# Access Compliance Report

## Public Rights-of-Way

### (Curb Ramps)

Intersection ID: 23951	Main Street: S_TRYON_ST	Cross Street: CHOATE_CR	Location: NE
ADA ID: AB45222B9650	Ramp Type: Perp	Initial Pass/Fail: Fail	Overall Compliance: No
		Severity Score: 12.5

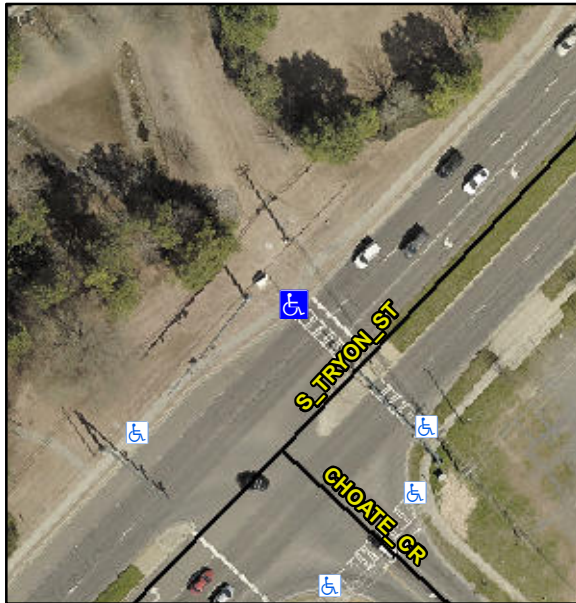
**Not Found, R304.2.2**

Compliance	Description	Data	Compliance	Description	Data
N/A	Ramp Length (in)	98.0	No	Ramp Slope (%)	8.5
Yes	Ramp Width (in)	48.0	Yes	Ramp XSlope (%)	0.7
N/A	Flare Type LT	N/A	N/A	Flare Type RT	N/A
N/A	Flare Slope LT (%)	N/A	N/A	Flare Slope RT (%)	N/A
N/A	Flare Traversable LT?	N/A	N/A	Flare Traversable RT?	N/A
N/A	Landing Length (in)	N/A	N/A	DWS Provided?	N/A
N/A	Landing Width (in)	N/A	N/A	DWS Contrast?	N/A
N/A	Landing Slope (%)	N/A	N/A	DWS Length (in)	N/A
N/A	Landing X Slope (%)	N/A	N/A	DWS Full Width?	N/A
N/A	Landing Curb? (Y/N)	N/A	N/A	DWS Offset (in)	N/A
N/A	Shared Landing?	N/A			
N/A	Gutter Ponding?	N/A	N/A	Gutter Slope (%)	N/A
N/A	Gutter Lip Ht (in)	N/A	N/A	Gutter X Slope (%)	N/A
N/A	Painted X Walk1?	Yes	N/A	Painted X Walk2?	N/A
	X Walk 1 Direction	To SE		X Walk 2 Direction	N/A
N/A	X Walk 1 Width (in)	99.0	N/A	X Walk 2 Width (in)	N/A
	X Walk 1 Slope (%)	3.3		X Walk 2 Slope (%)	N/A
	X Walk 1 X Slope (%)	0.1		X Walk 2 X Slope (%)	N/A

**Remove & Replace Entire Ramp.**
